*Planning & Community Development
Type II Decision Recommendation
Administrative Design Review
Public Meeting: July 11, 2019 at 6:00pm*

Costco Design Review

LUA2019-0081

SITE PHOTOMETRIC PLAN
SCALE: 1" = 50'-0"

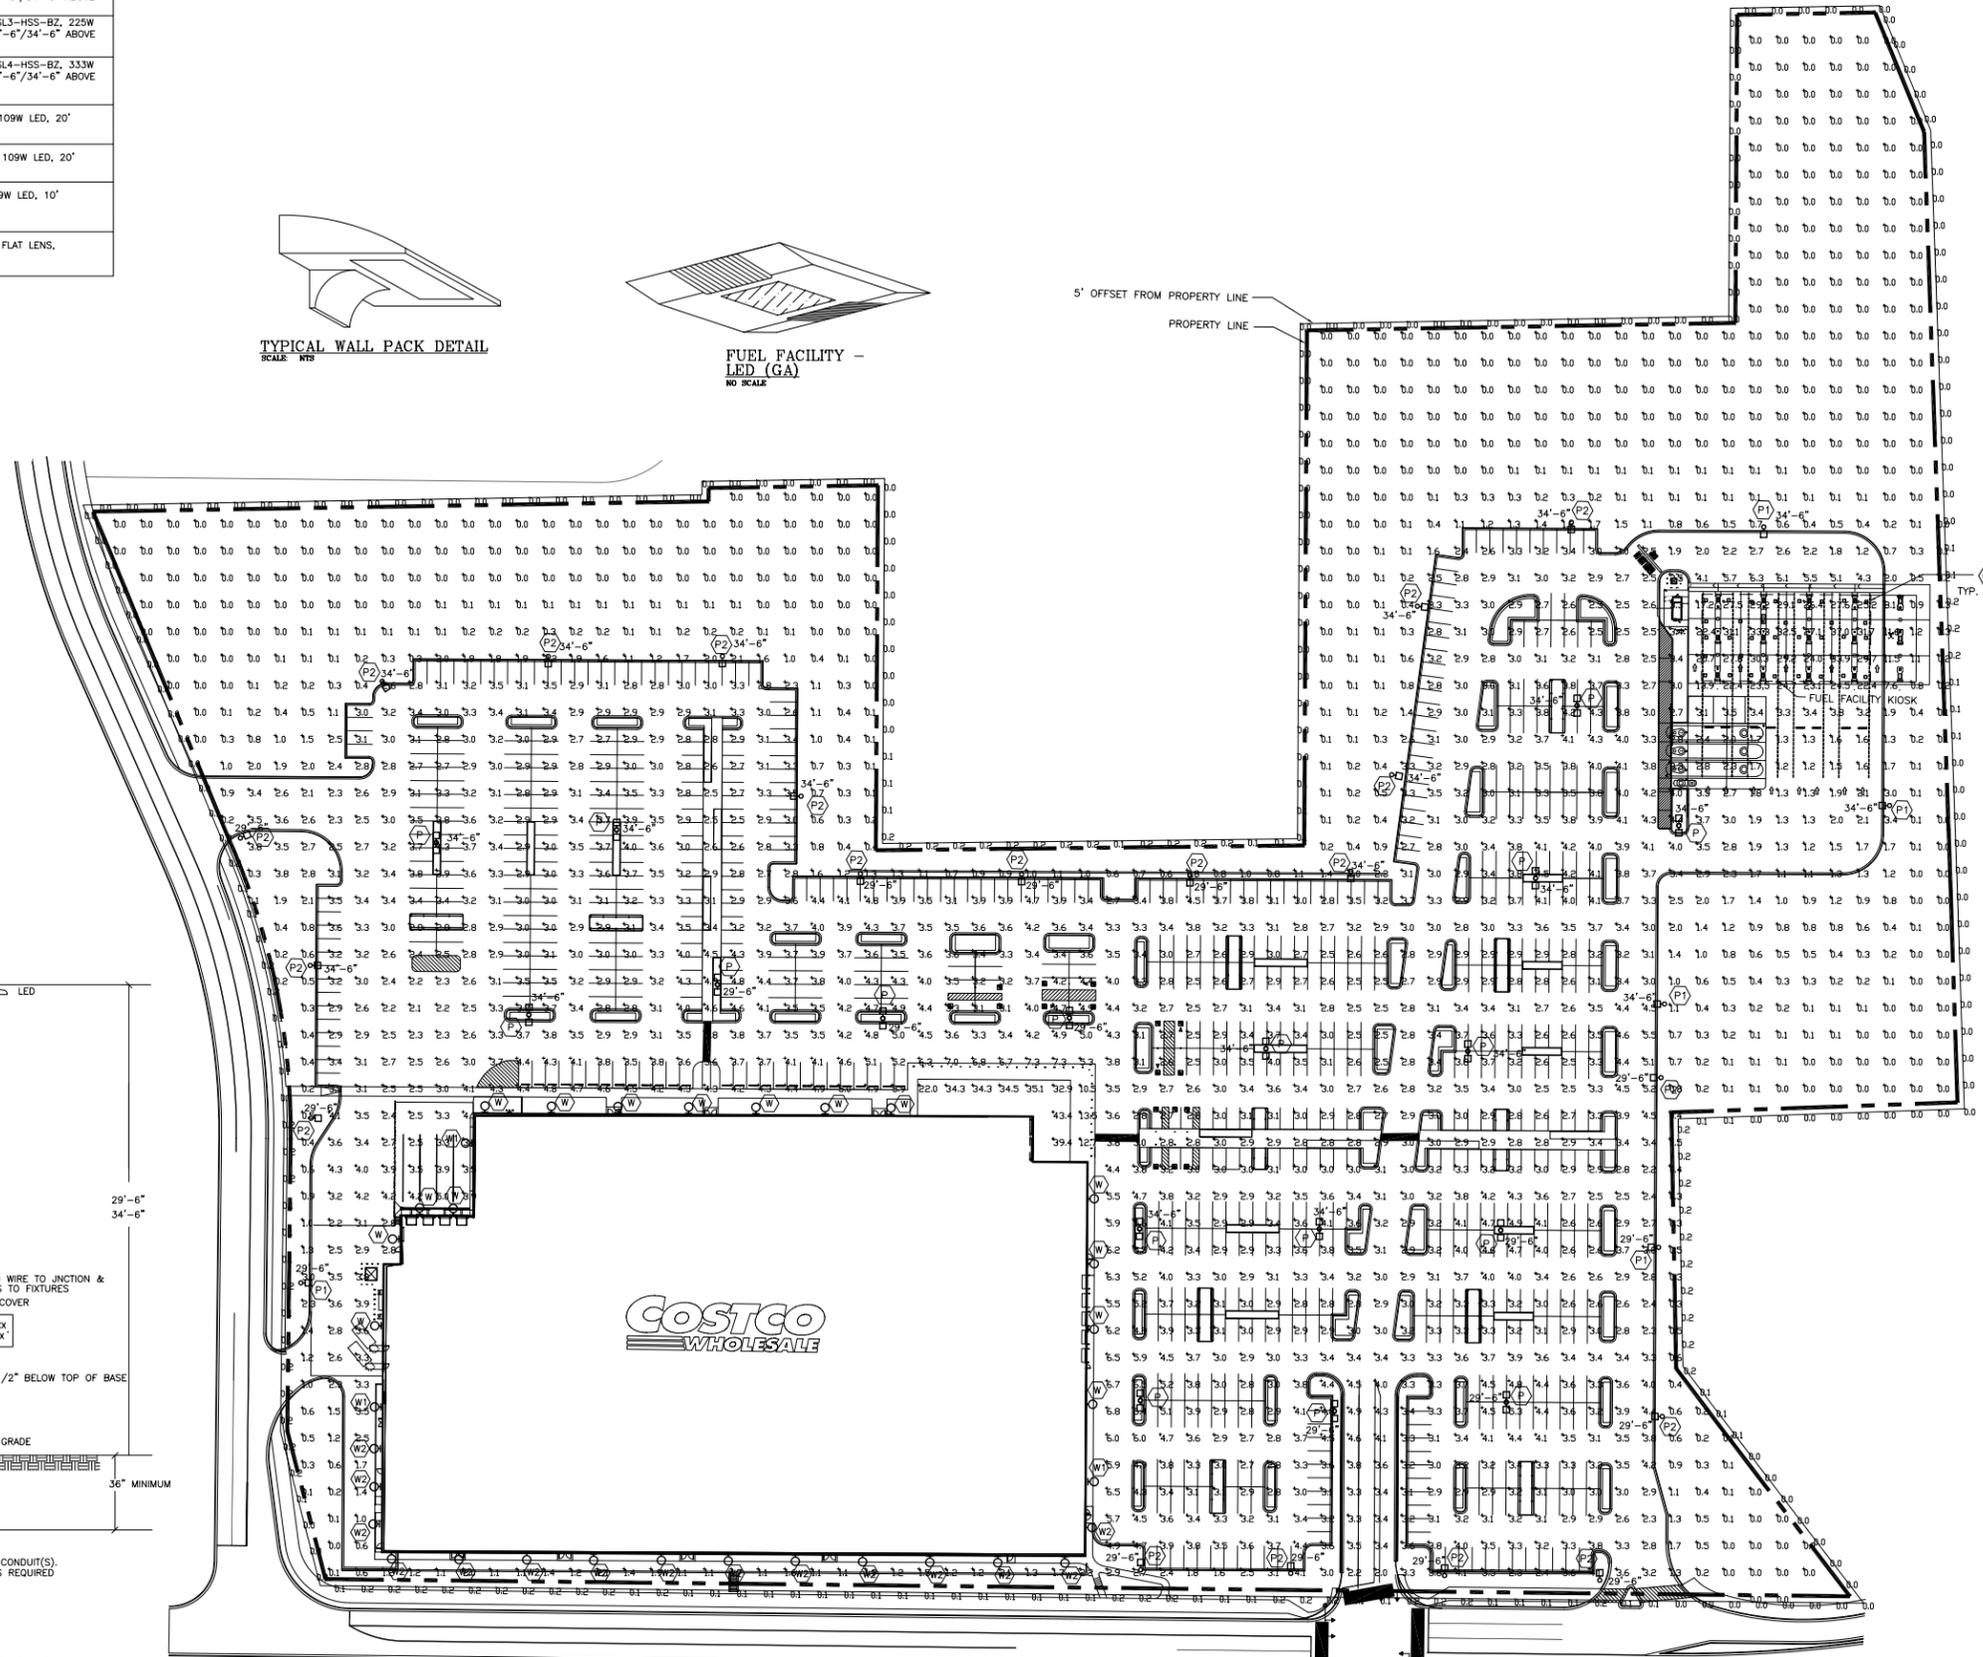
- b. Sheet SE-1 – the Photometric plan shows light levels likely higher than allowed by municipal code (two-tenths foot candles, measured five feet or beyond from an exterior property line) at the north end of the parking lot adjacent to 93rd Dr SE. Please address to make compliant.

measured five feet or beyond from an exterior property line per LSMC 14.38.080(b)(2)(iii). The revised photometric plan provided on October 31, 2019 demonstrated compliance with the above section of code.
